**DECISION, FINDINGS OF FACT AND CONCLUSIONARY FINDINGS OF THE MCMINNVILLE HISTORIC LANDMARKS COMMITTEE FOR THE APPROVAL OF ALTERATIONS TO A HISTORIC LANDMARK LOCATED AT 714 SE WASHINGTON STREET**

- DOCKET:** HL 4-19 (Certificate of Approval for Alteration)
- REQUEST:** Approval of alterations to an existing historic landmark and building that is listed on the McMinnville Historic Resources Inventory as a “Significant” historic resource (resource number B886). The proposed alterations include replacement of vinyl windows with wood windows, replacement and enlargement of doors, replacement and expansion of a deck on the side and rear of the building, addition of an open wood trellis above the deck, and the addition of a new detached two car garage with an accessory dwelling unit above the garage.

- LOCATION:** 714 SE Washington Street. The property identified as Tax Lot 10500, Section 21CB, T. 4 S., R. 4 W., W.M.
- ZONING:** R-4 (Multiple Family Residential)

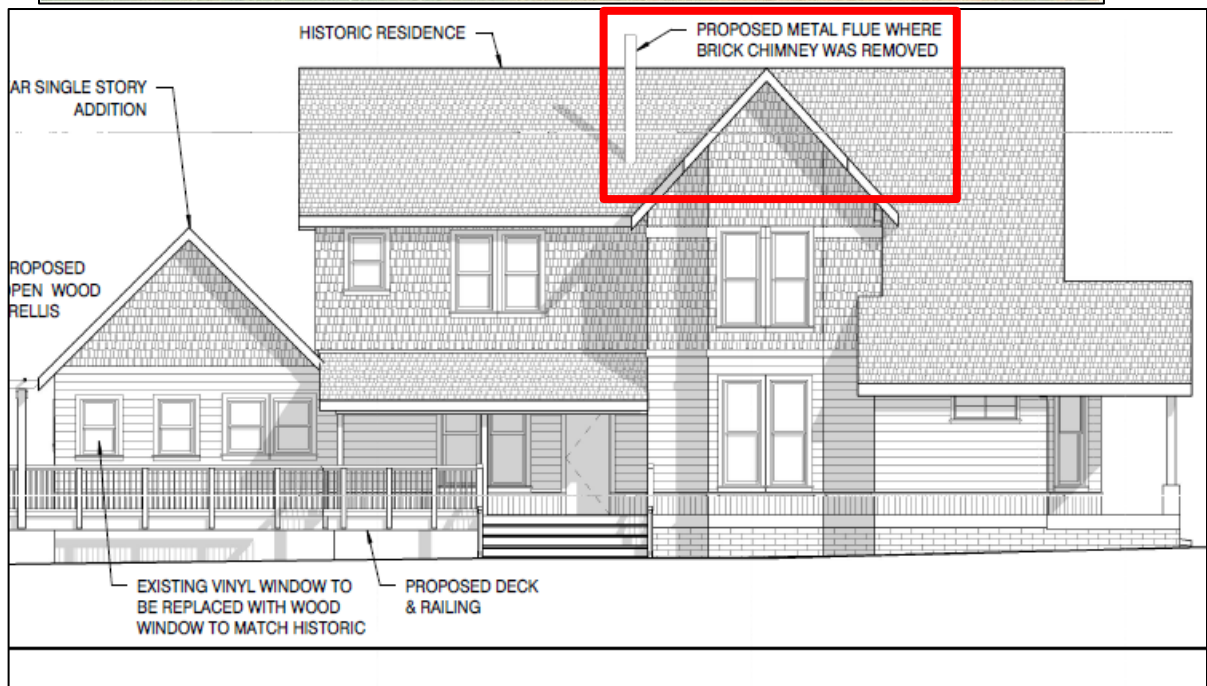
There is one remaining chimney that is proposed to be removed and replaced with a metal flue. The applicant has noted that this metal flue would not be visible from the street. However, the height of the metal flue projects above the height of the roof, and the material of the metal flue is not consistent with the historic character of the property. Therefore, a condition of approval is included to allow the internal changes and the addition of the wood burning stove and metal flue, but require that the metal flue be encased in either the repaired brick chimney or a new brick chimney that replicates the existing chimney that is still present on the historic residential structure. The location and height of the proposed metal flue can be seen below:

**Finding:** As described in more detail above, a condition of approval is included to require that the existing brick chimney be replaced around the new metal flue proposed to serve the new internal wood burning stove.

1. The existing brick chimney shall either be repaired or replaced by a similar brick chimney that will encase the proposed metal flue associated with the addition of a wood burning stove in the historic residence. The repaired or new brick chimney should match the existing chimney in height, depth and any assorted brick design.

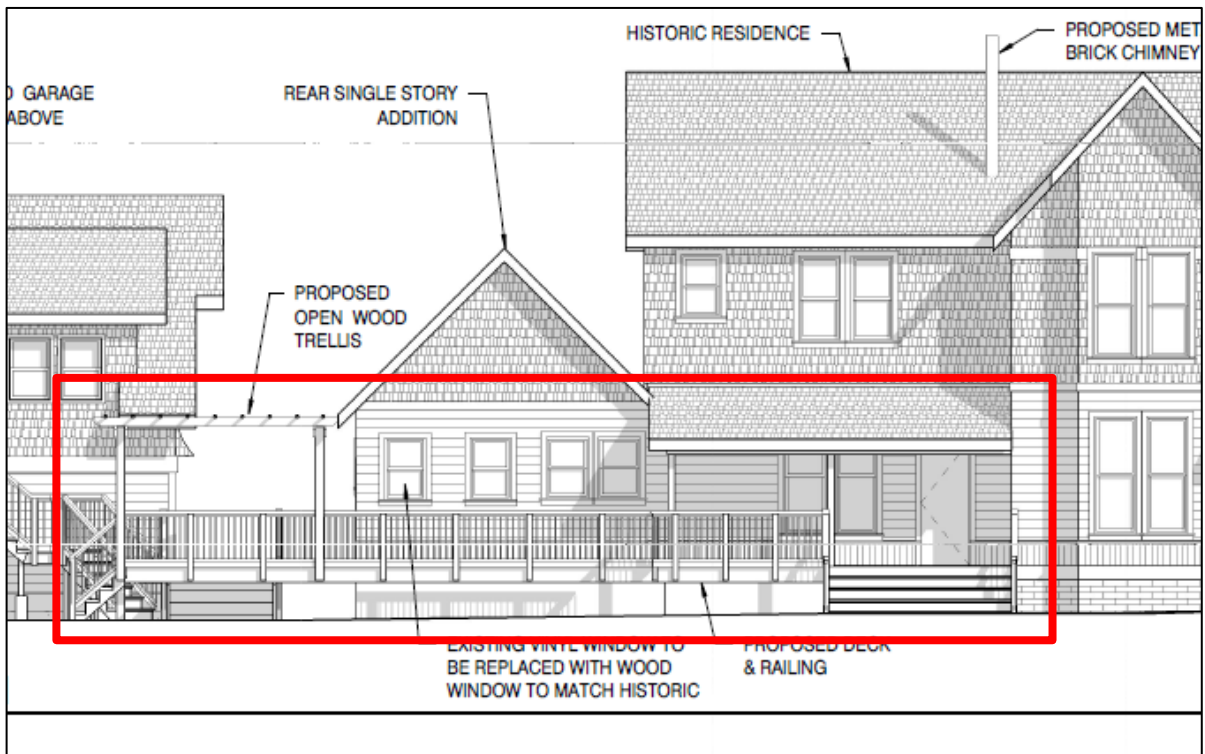
At east elevation, the new deck is not a concern, but the stair to the deck appears to have inadequate head height at the stair landing under the existing porch roof. It may be inadequate currently but if re-built, the stair must have a minimum of 6’-8” of head height measured from the stair nosing and the entire landing area.

The applicant is also proposing to remove and replace the deck located underneath the porch on the east façade of the historic structure. The replacement deck will be expanded in size to the east and south, and will also include the addition of a trellis at the southern portion of the deck. The existing deck stairs and railing are not compatible with the existing structure, and the proposed deck, while expanded in size, will be constructed of materials that are more consistent with the materials in use on the existing historic structure. The new deck and railing will be wood materials and will include round straight balusters and wood rails. The existing

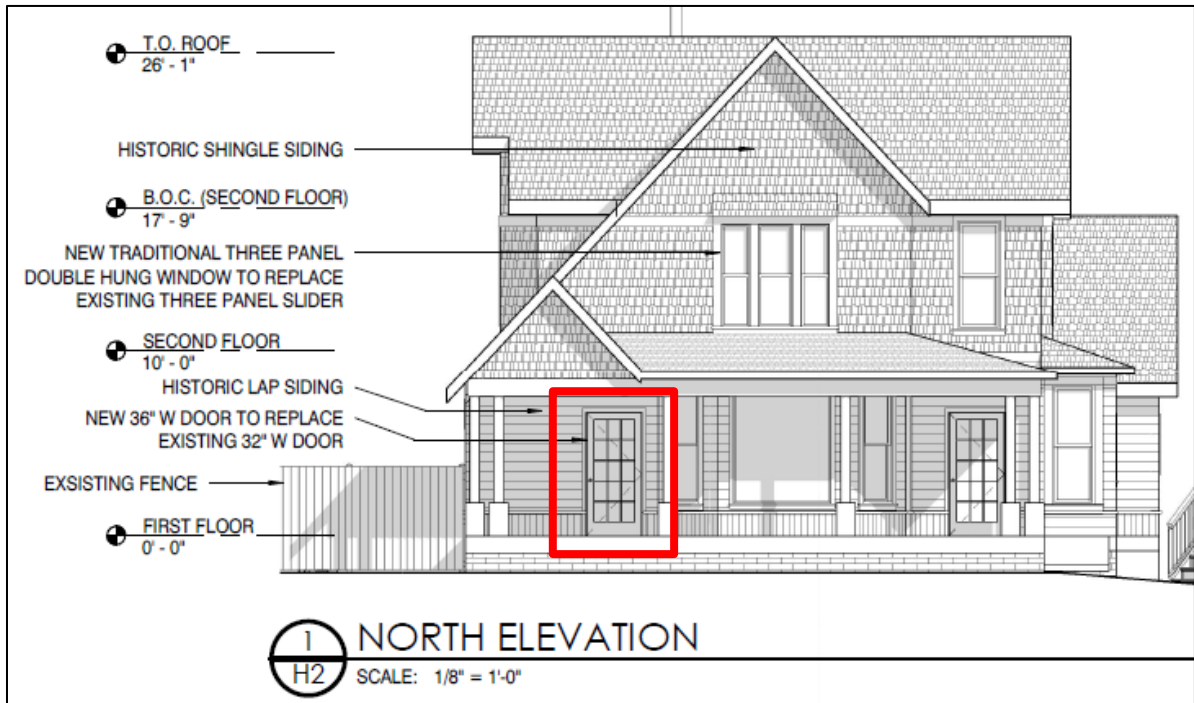
**FINDING: SATISFIED WITH CONDITIONS #2 and #3.** The City concurs with the applicant's findings, but adds that some of the application narrative, plans, and elevations do not specifically identify replacement materials. Therefore, a condition of approval is included to require that all windows and doors proposed to be replaced be replaced with wood windows and doors to match

the existing structure’s materials, and that the windows and doors on the garage and ADU be wood. The condition of approval specifies that the design of the wood trim and window sills around the windows and doors shall also match the window trim of the existing structure.

2. That all windows and doors proposed to be replaced be replaced with wood windows and doors to match the existing structure’s materials. The new windows and doors on the garage and ADU shall also be of wood materials. The replacement and new windows and doors shall include the wood trim and window sill design that exists on the remainder of the windows and doors on the existing structure.
